SERVICE BULLETIN

SUBJECT: MOONEY M20J (201) COWL FLAP HINGE MODIFICATION

MODELS/S/N  
AFFECTED: Mooney M20J (201) S/N 24-0001 thru 24-1546

FIGURE M20-231-1

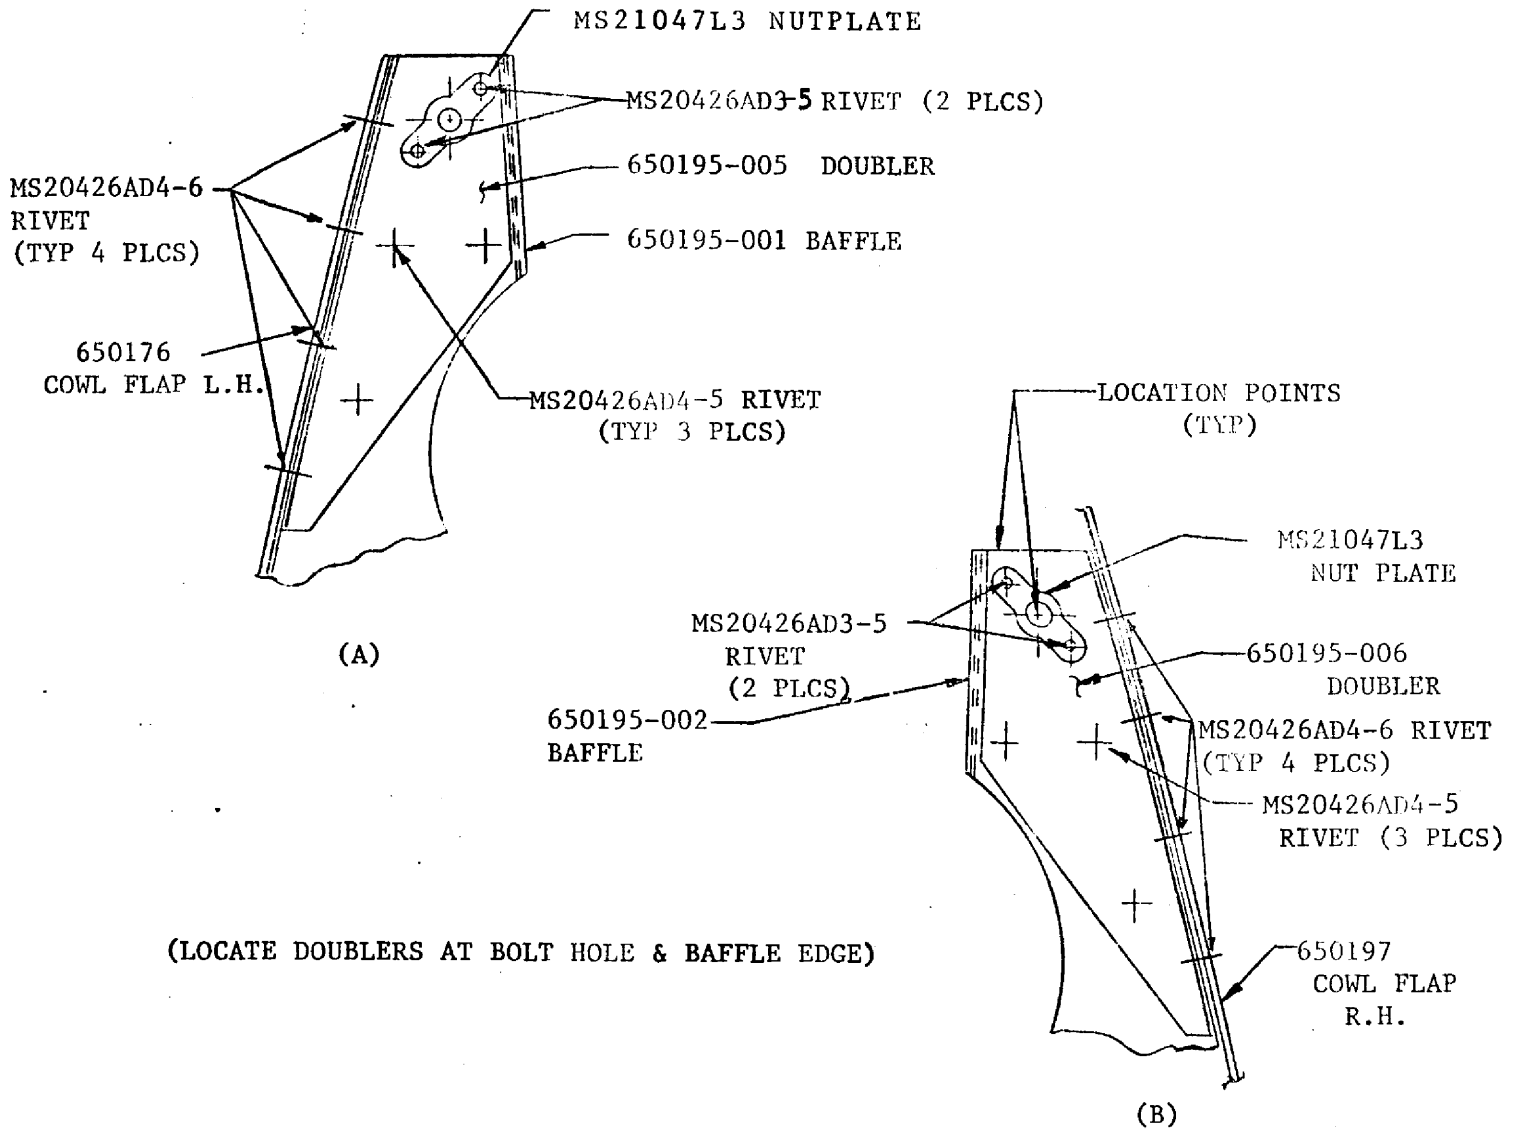
3. L.H. cowl flap assy, P/N 650176-501 - Remove the MS 21047L3 nut plate from inboard baffle, 650195-1.  
NOTE: Countersink all holes on lower flange; doubler must lay flat on dimpled area. Locate doubler, P/N 650195-5, per Figure M20-231-1(A) and drill holes to match in doubler, baffle and flange. Install doubler using MS 20426AD4 rivets. Install new nut plate, MS 21047L3, using MS 20426AD3-5 rivets. Inspect cowl flap to see that there are also doublers at aft end of each baffle. There should be a doubler, P/N 650195-3, on the inboard baffle and, P/N 650196-3, doubler on outboard baffle, 650196-001, refer to Figure M20-231-2(A), (B), and (C). If not installed, order Opt. Kit SB M20-231-002.

4. R.H. cowl flap assy, P/N 650197-502 - Remove the MS 21047L3 nut plate from inboard baffle. Locate, P/N 650195-6, doubler per Figure M20-231-1(B) & drill holes to match in doubler, baffle and flange. Install doubler using MS 20426AD4 rivets. Install new nut plate, MS 21047L3, using MS 20426AD3-5 rivets. Inspect cowl flap to see that the doubler, P/N 650196-4, is installed on aft end of outboard baffle, 650196-2, refer to Figure M20-231-3(A) & (B). If not installed, order Opt. Kit SB M20-231-002.

FIGURE M20-231-4

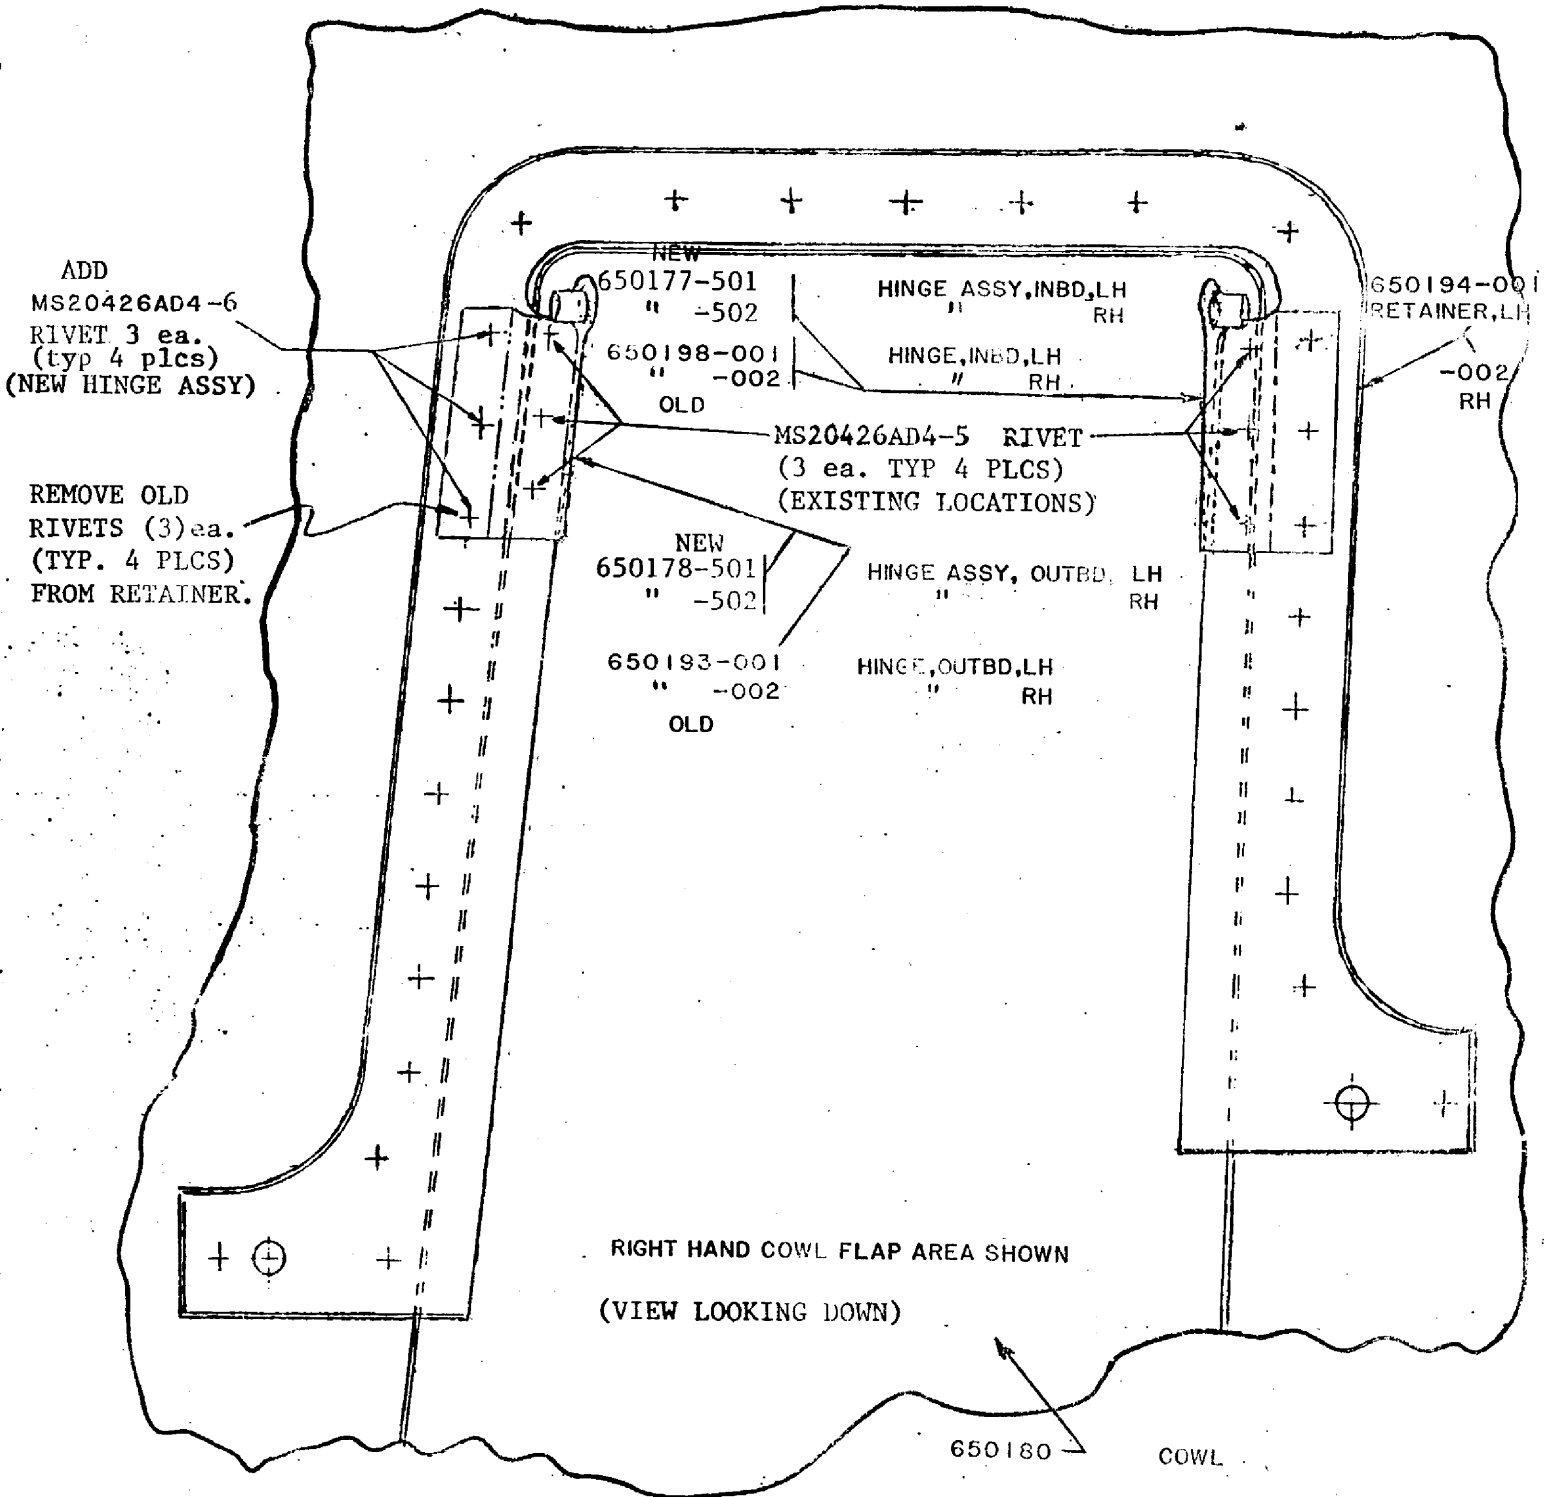
5. Rework lower cowl assy, 650180, to modify the cowl flap hinge assy by drilling out three (3) rivets from each old hinge bracket, P/N 650193 and 650198 (four (4) hinge brackets total). Drill twelve (12) additional rivets from the retainers P/N 650194-1 and -2, (three (3) at each new hinge bracket location), refer to Figure M20-231-4

(TYPICAL HINGE/BOLT INSTALLATION)  
FIGURE M20-231-5

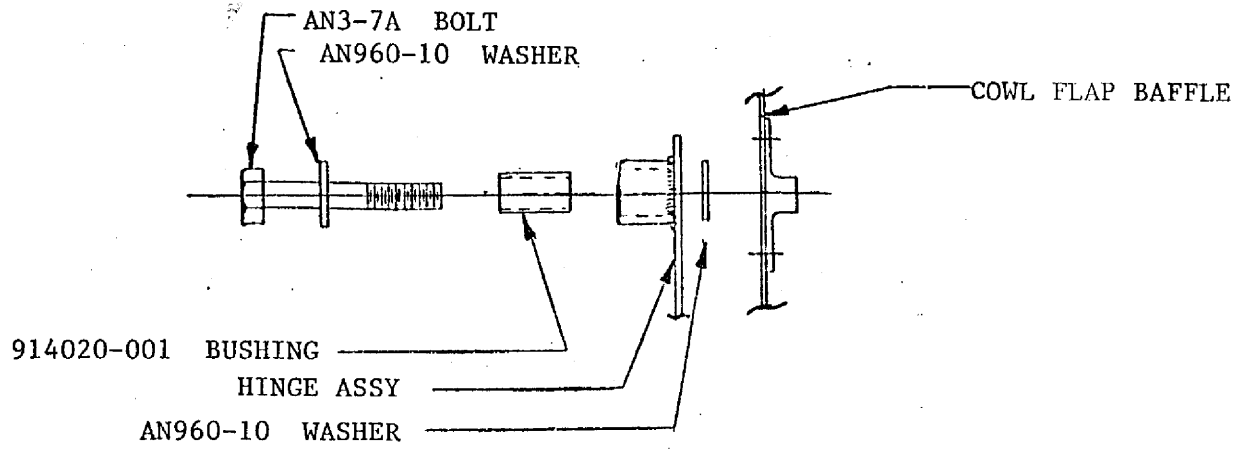
6. Assemble the four new hinge assy brackets, P/N 650177-501 and 650178-501 to the left hand cowl flap and P/N 650177-502 and 650178-502 to the right hand cowl flap using the new hardware and bushings provided with the kit, ref. Figure M20-231-5.

It is necessary to align the hinge pivot points exactly on Sta. -17.375 (the same as existing pivot point) when installing four (4) new hinge assy brackets.
